Addendum 33 – Regulation No. 34

Revision 2 - Amendment 2

03 series of amendments – Date of entry into force: 15 June 2015

Uniform provisions concerning the approval of vehicles with regard to the prevention of fire risks

"Model B

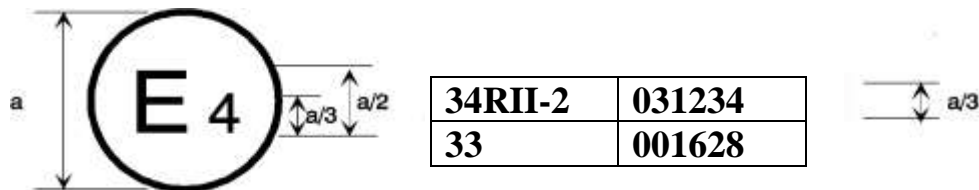
Annex 2, Model B, amend to read:

a = 8 mm minimum

The above approval mark affixed to a vehicle shows that the type concerned was approved in the Netherlands (E 4) pursuant to Regulations Nos. 34 Parts I or IV and II-1 and 33*. The approval numbers indicated that, at the date when the respective approvals were given, Regulation No. 34 included the 03 series of amendments and Regulation No. 33 was still in its original form.

The above approval mark affixed to a vehicle shows that the type concerned was approved in the Netherlands (E 4) pursuant to Regulations Nos. 34 Parts I or IV and II-2 and 33*. The approval numbers indicated that, at the date when the respective approvals were given, Regulation No. 34 included the 03 series of amendments and Regulation No. 33 was still in its original form."
